Access Compliance Report

Public Rights-of-Way

Intersection ID: 31492	Main Street: CLOVER_GAP_DR	Cross Street: JORDANS_POND_LN	Location: W
ADA ID: C724AA8C8268	Ramp Type: Perp	Initial Pass/Fail: Fail	Overall Compliance: No
		Severity Score: 8.75

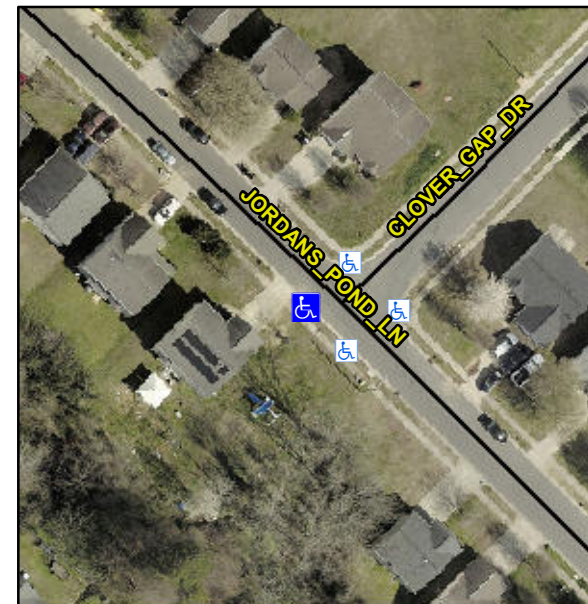
Not Found, R304.5.1

Compliance	Description	Data	Compliance	Description	Data
N/A	Ramp Length (in)	48.0	Yes	Ramp Slope (%)	5.0
No	Ramp Width (in)	45.0	Yes	Ramp XSlope (%)	0.8
N/A	Flare Type LT	N/A	N/A	Flare Type RT	N/A
N/A	Flare Slope LT (%)	N/A	N/A	Flare Slope RT (%)	N/A
N/A	Flare Traversable LT?	N/A	N/A	Flare Traversable RT?	N/A
N/A	Landing Length (in)	N/A	N/A	DWS Provided?	N/A
N/A	Landing Width (in)	N/A	N/A	DWS Contrast?	N/A
N/A	Landing Slope (%)	N/A	N/A	DWS Length (in)	N/A
N/A	Landing X Slope (%)	N/A	N/A	DWS Full Width?	N/A
N/A	Landing Curb? (Y/N)	N/A	N/A	DWS Offset (in)	N/A
N/A	Shared Landing?	N/A			
N/A	Gutter Ponding?	N/A	N/A	Gutter Slope (%)	N/A
N/A	Gutter Lip Ht (in)	N/A	N/A	Gutter X Slope (%)	N/A
N/A	Painted X Walk1?	No	N/A	Painted X Walk2?	N/A
	X Walk 1 Direction	To NE		X Walk 2 Direction	N/A
N/A	X Walk 1 Width (in)	N/A	N/A	X Walk 2 Width (in)	N/A
	X Walk 1 Slope (%)	4.2		X Walk 2 Slope (%)	N/A
	X Walk 1 X Slope (%)	1.1		X Walk 2 X Slope (%)	N/A

Remove & Replace Entire Ramp.
